dsPIC30F4011/4012 Family Silicon Errata and Data Sheet Clarification

The dsPIC30F4011/4012 family devices that you have received conform functionally to the current Device Data Sheet (DS70135F), except for the anomalies described in this document.

FIGURE 1: dsPIC30F4011/4012 DATA EEPROM

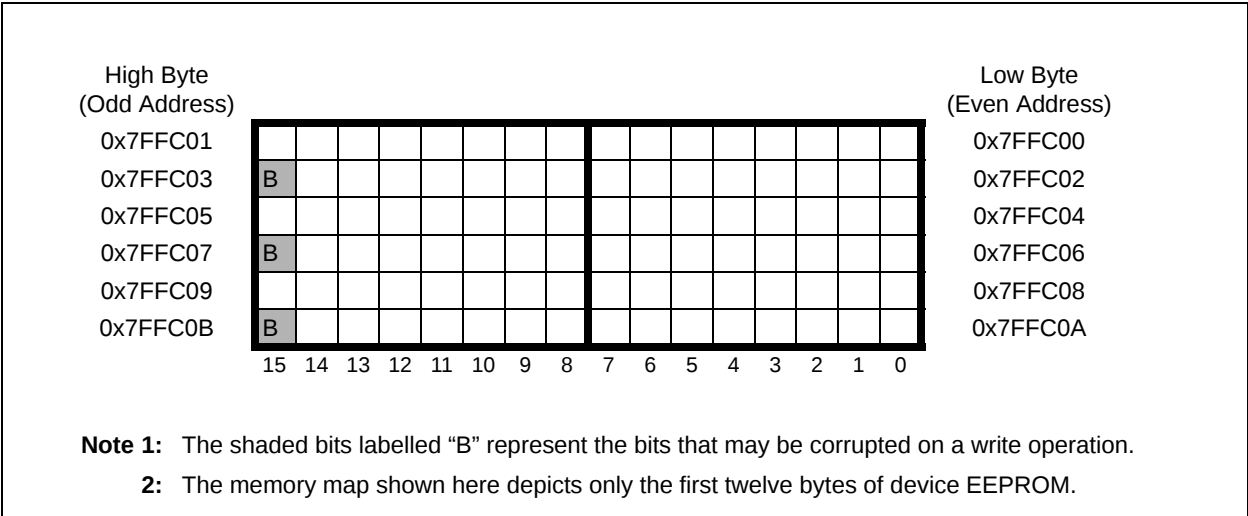
The Most Significant bit of every fourth byte in data EEPROM may be corrupted on any write operation. This write corruption may occur while using either PRO MATE®, MPLAB ICD 2 or Run-Time Self-Programming (RTSP).

Figure 1 shows the first twelve bytes in data EEPROM and indicates the affected bits.

Use program Flash memory instead of data EEPROM to store constant data.

Use less than 16 bits in each word in the available word of data EEPROM, excluding the Most Significant bit.

Avoid using every fourth byte. Example 11 shows how the ASM30 assembler can be used to allocate data in the EEPROM under this constraint.
